KNOXVILLE/KNOX COUNTY METROPOLITAN PLANNING COMMISSION
SUBDIVISION REPORT - CONCEPT

FILE #: 2-SB-14-C AGENDA ITEM #: 8

SUBDIVISION: CENTURY PARK AT PELLISSIPPI

**2-SB-14-C
CONCEPT PLAN**

CP 1.00

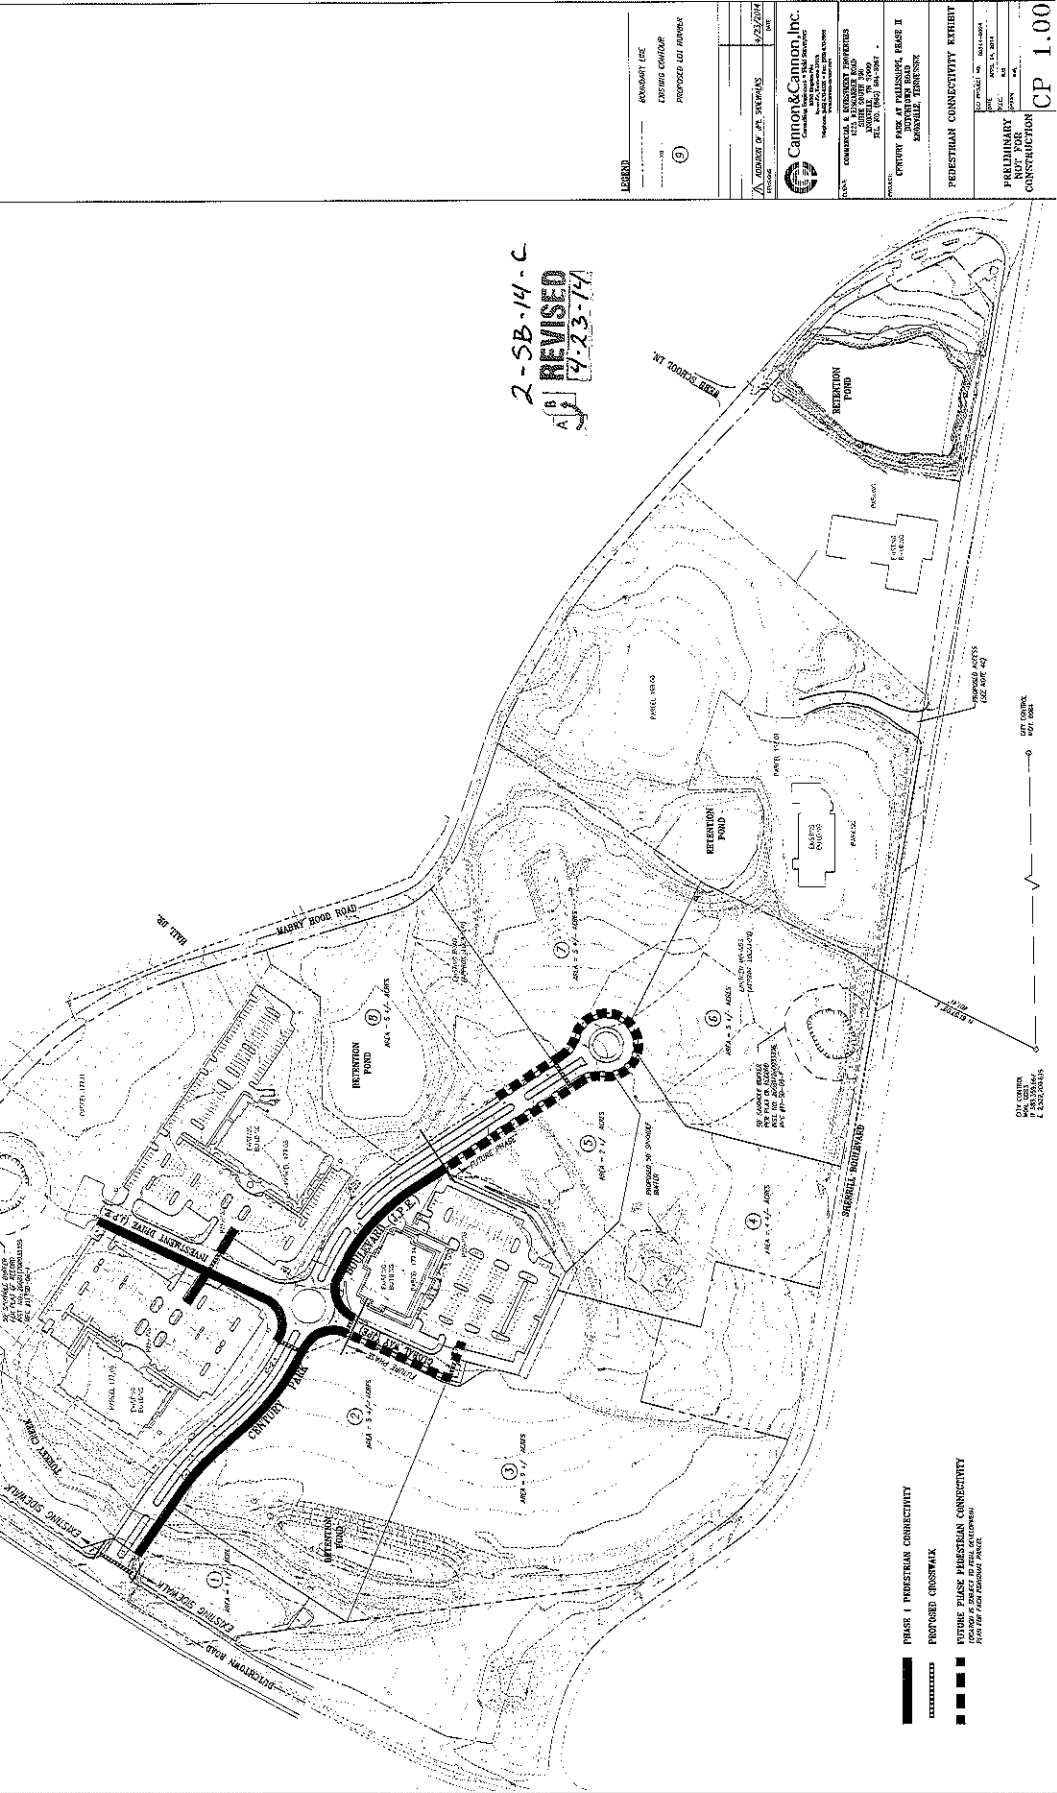
APPROVE the Concept Plan subject to 9 conditions:

- 1. Connection to sanitary sewer and meeting any other relevant requirements of the Knox County Health Department.
2. All lots shall have access only to the internal street system except Lot 1 which will be allowed restricted access to Dutchtown Rd.
3. Sidewalks with a minimum width of 5', and meeting the City of Knoxville and the Americans with Disabilities Act (ADA) requirements, shall be installed following the proposed sidewalk layout identified on the revised

"Pedestrian Connectivity Exhibit" for the Concept Plan (dated April 23, 2014). The sidewalks identified as Phase 1 on the revised plan shall be installed by the developer as part of the next C-6 development for which a building permit is issued. The Phase 1 sidewalks and the sidewalks along the Joint Permanent Easement (JPE) frontage and internal to the site for that specific development shall be completed with final approval by the City of Knoxville Department of Engineering prior to a certificate of occupancy being issued for any building on the development lot. The remaining sidewalks identified on the revised plan shall be approved and installed as part of the C-6 development approval for each lot within the subdivision. Under future phases, each sidewalk segment along the JPE serving the Subdivision and the sidewalks internal to a specific C-6 development, shall be completed and approved by the City of Knoxville Department of Engineering prior to a certificate of occupancy being issued for any building on the C-6 development lot.

4. Installing a traffic signal at the intersection of Century Park Blvd. and Dutchtown Rd. at such time that it is warranted by actual traffic volumes. A traffic signal warrant analysis may be required by Planning Commission staff for any future C-6 development review application within the Century Park development. The cost of the traffic signal and the traffic signal warrant analysis shall be born by the developer. The design and installation of the traffic signal is subject to approval by the Knox County Department of Engineering and Public Works and the Knoxville Department of Engineering.

6. If any building construction is proposed within the 50 buffer area around any designated sinkhole, a geotechnical report must be prepared by a registered engineer to determine soil stability and that report must be submitted to the Knoxville Department of Engineering for consideration. Any construction in these areas is subject to approval by the City following review of the report. Engineered footings must be designed for these areas.
